MEMORANDUM

SUBJECT: Site Plan Approval Amendment – 111 Breen Avenue

RE: Pete's Trattoria Parking Lot Expansion Site Plan Approval Comment Response Letter
Tax Map P.N. 8-01-214.100 (Pete's Trattoria)
111 Breen Avenue, City of Watertown, New York

CONCEPTUAL MASTER PLAN PETE'S TRATTORIA PARKING LOT EXPANSION

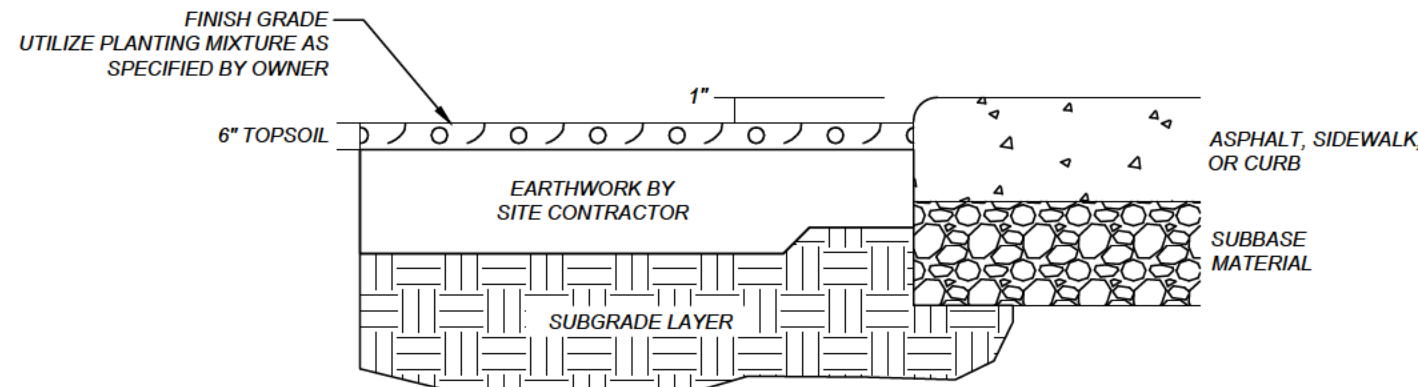
The parking addition, as now proposed, would exclusively serve Pete's Trattoria on the subject parcel. The applicant has included a conceptual master plan (Sheet C104) that depicts the original proposal with a note that the applicant's client supports the concept. However, any potential future improvements on 710 Arsenal Street would require The Marcy Spa and Salon Inc. to apply for and obtain the necessary approvals, including but not limited to a new Site Plan Approval and a NYSDOT Highway Work Permit.

1. The should consider providing a dedicated pedestrian connection from the Arsenal Street sidewalk to the Marcy Spa door as discussed at the June 9, 2026 Planning Commission meeting and reflected in the minutes thereof.

Concur. This comment is obsolete after the reduction in scope, however, as shown on C104 for future planning purposes, this connection is conceptually shown.
